SITE 1A & 1B  
ALATUS – MULTIFAMILY HOUSING 1 &  
ENTREPRENEURIAL MARKET  
CIVIL DRAWING INDEX

BROOKLYN  
CENTER -  
ALATUS -  
MULTIFAMILY  
HOUSING 1

ALATUS -  
MULTIFAMILY  
HOUSING 1 - CIVIL  
NOTES AND  
LEGEND

PPL & RFWM - FAMILY HOUSING - GRADING AND DRAINAGE PLAN

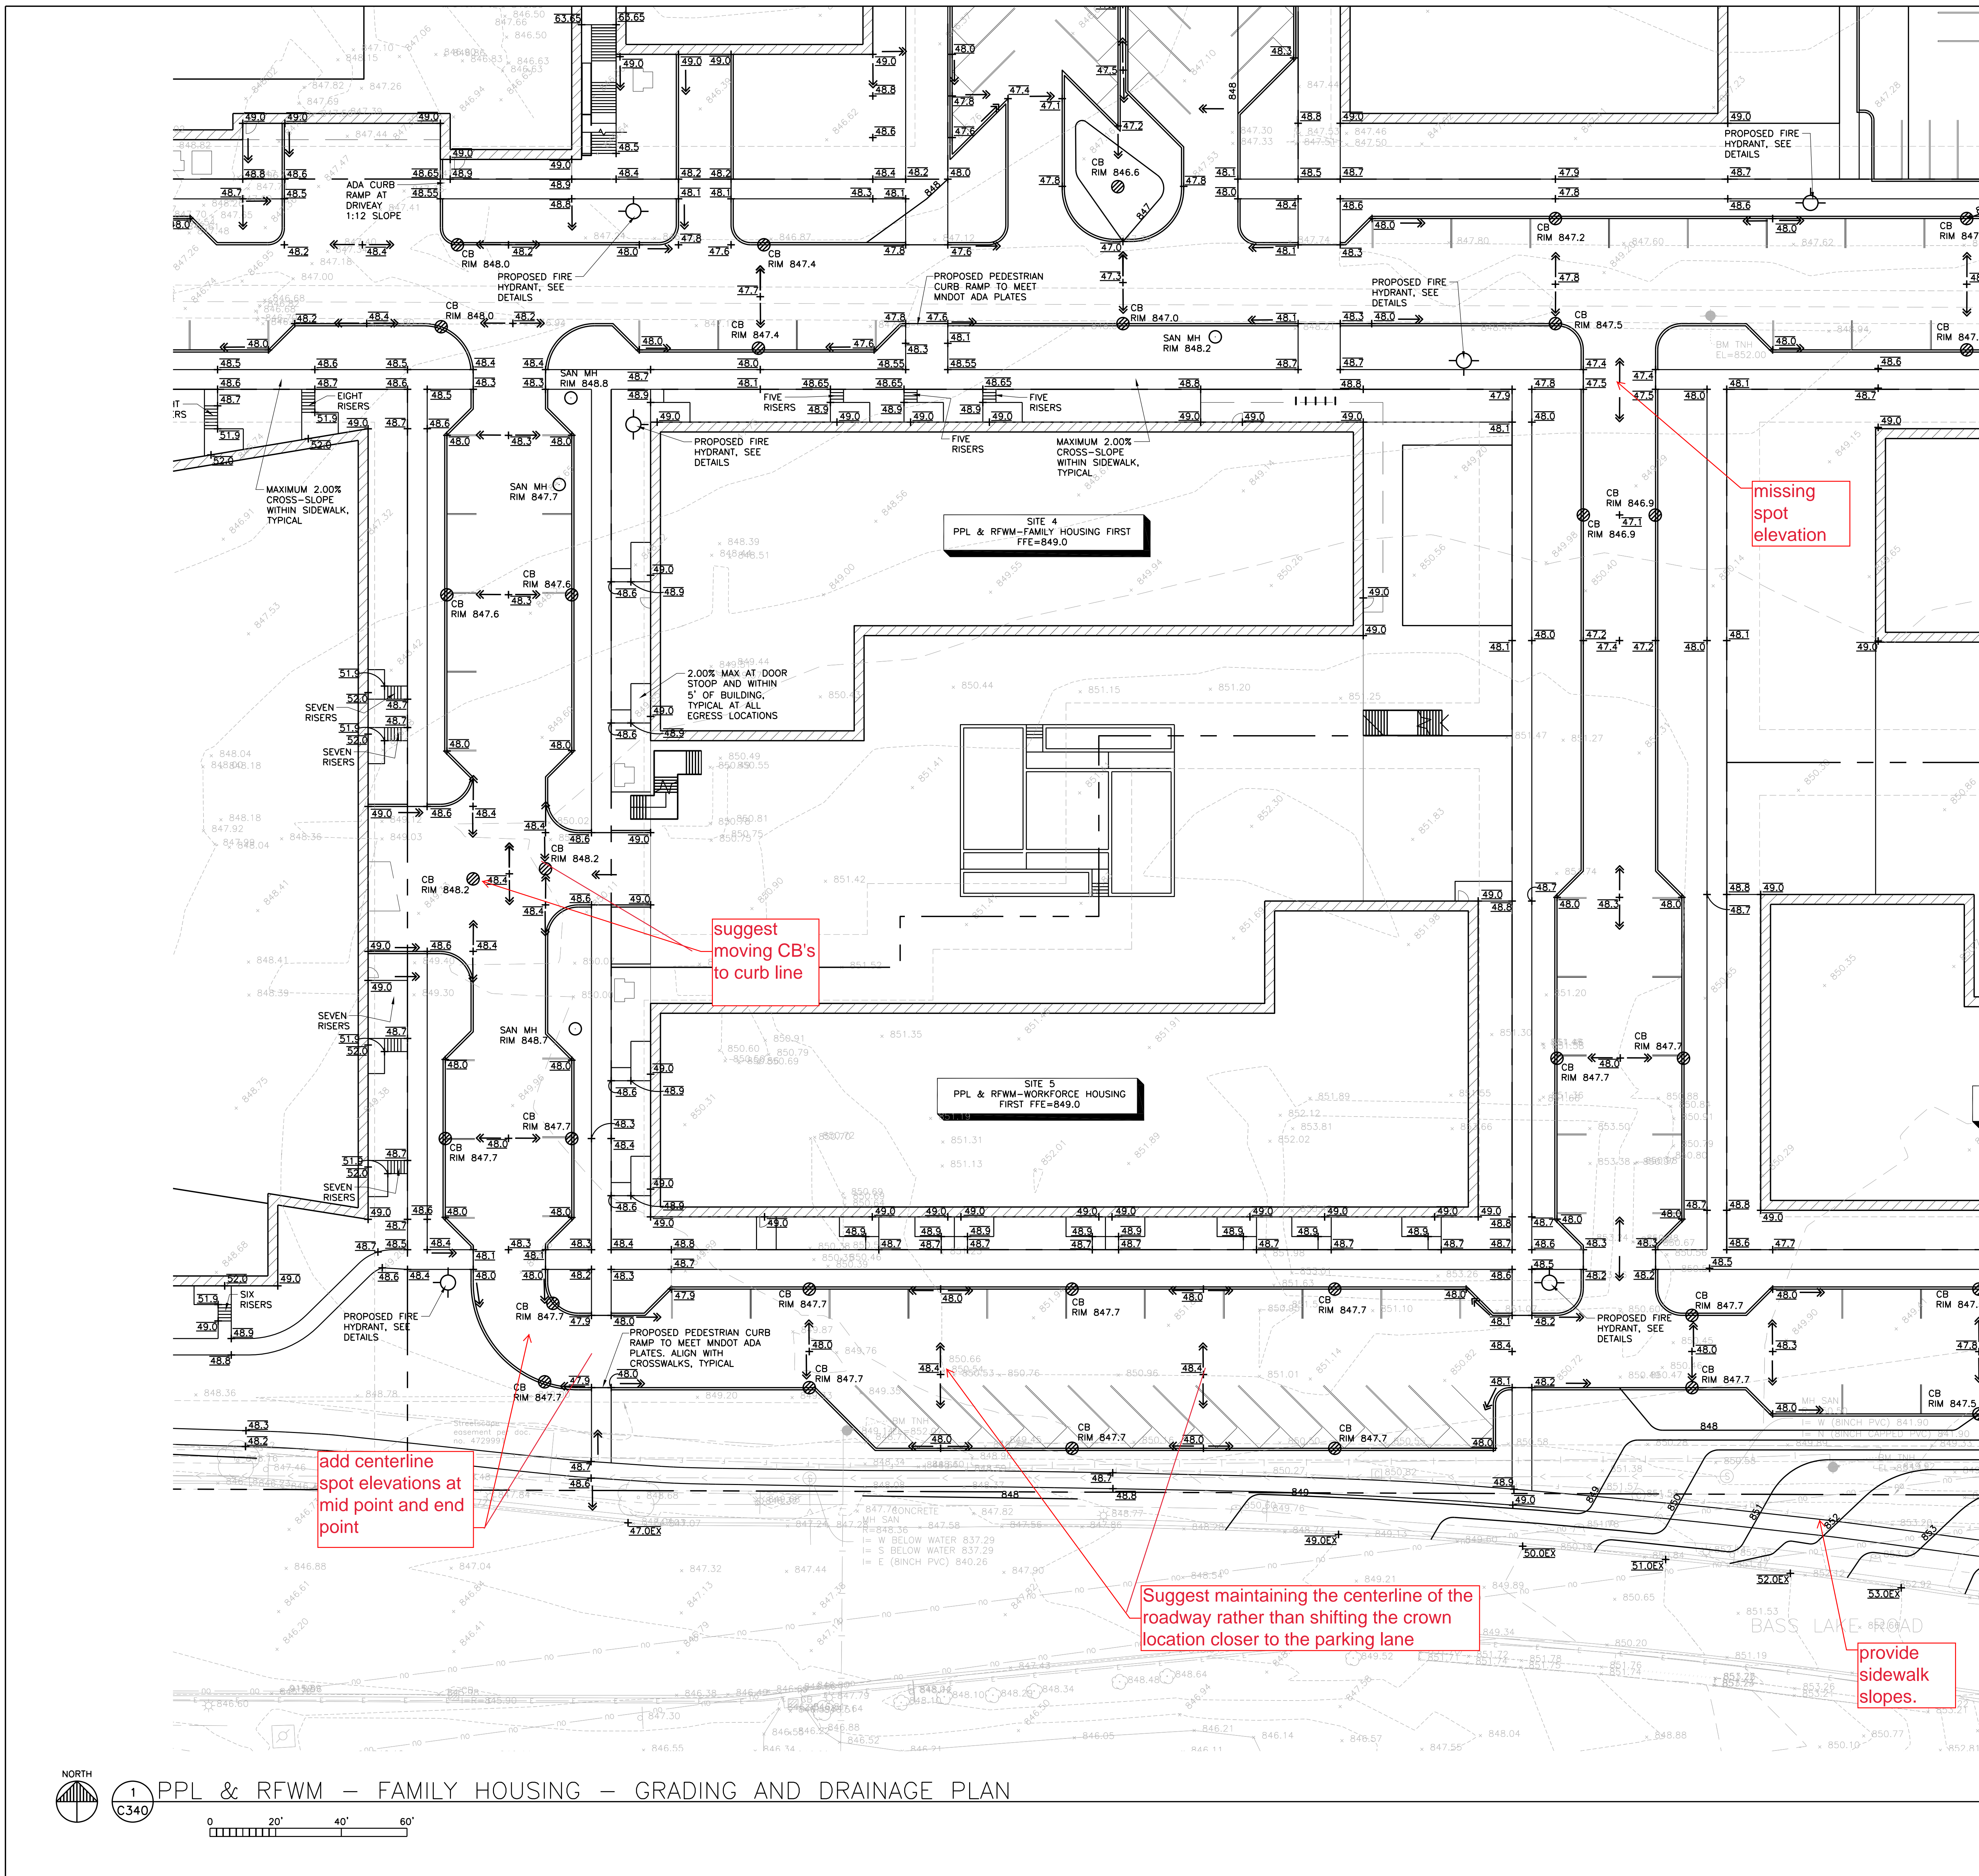
Provide interim grading plan for sites for sites 6 & 7

missing spot elevation

add centerline spot elevations at mid point and end point

provide sidewalk slopes.
